ADDENDUM TO INVITATION FOR BID

RE: Addendum No. 8: **IFB-KW-19-244 – Ridge Road Extension – Phase I**

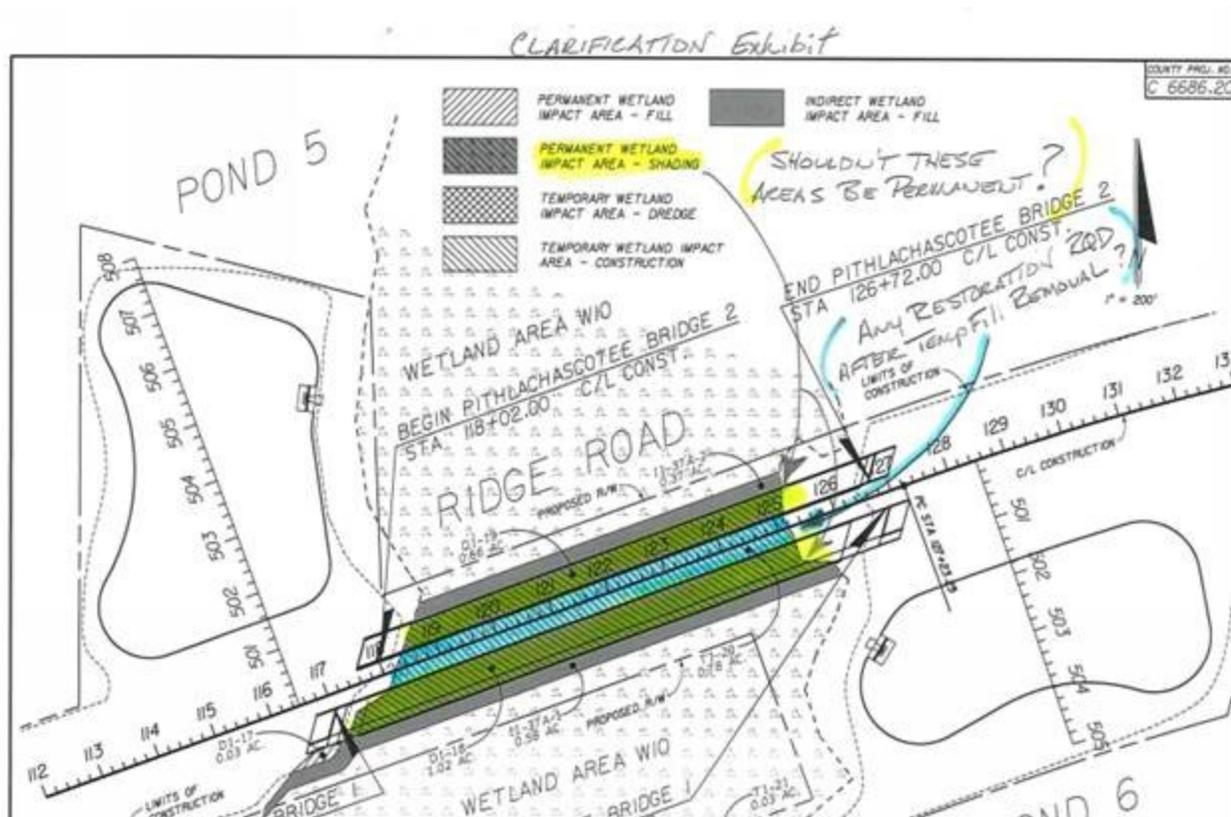
Question 9: The below clip from the permit shows no permanent impacts beneath the bridges. I have never seen on a permit before where the area beneath the bridge wasn't designated as a kill zone/permanent impact area. Could the fill pattern not have printed correctly here? The permit document shows 2.66 Acres of permanent impacts to Wetland Area W10, but this drawing depicts none (This is the same at all bridges). This drawing also depicts the area between the bridges as Temporary Impacts – Construction. Answer 40 in Addendum 6 states restoration is required in temporary impact areas, like shown below between the bridges. However, answer 37 in addendum 3 stated no restoration would be required in this area as long as clearing restrictions are followed. Can the engineer clarify the permit, permanent shade impacts, restoration requirements, and restoration measures required when necessary?

Answer 9: The area beneath all the bridges is designated as a permanent shading impact. These areas are not designated as a “kill zone”. The wetland functional loss associated with these areas is based on permanent shading and limited cutting of trees, not permanent fill or other permanent impacts. There are strict limitations to the permitted disturbance and contractor operations beneath the bridges that are described on sheet 605, Special Detail (3).

The 2.66 acres of permanent impact areas for W-10 is correct and is made up of the area under the two bridges (1.68 acres) the indirect impact area outside of the two bridges (0.95 acres) and the permanent fill area at the west end of the eastbound bridge (0.03 acres). Note that no actual direct or temporary impacts are allowed within the indirect impact area outside of the two bridges. It is functional loss of the area and not just the acreage that is considered for all the permanent impact areas when mitigation needs are established.

The area between the bridges is designated as a temporary impact area as it is where the temporary work platform may be placed to facilitate construction of the bridges should the contractor choose to do so. The plans, Special Detail (1) and (2), describe the possible type, size and maximum duration for the temporary impacts that are permitted between the bridges. The plans specify the contractor is responsible for restoration of the area between the bridges per the permit requirements which would include removal of all matting, fill and geotextile to the original grade. The detail sheets specify clearing limitations in these areas and complying with these limitations is critical to limiting the restoration to only removal of the platform materials to original grade. No other restoration should be required unless the contractor had deviated from the clearing or time limitation requirements specified in the plans in which case restoration in accordance with GC 7.13 may be required to the satisfaction of the environmental agencies.
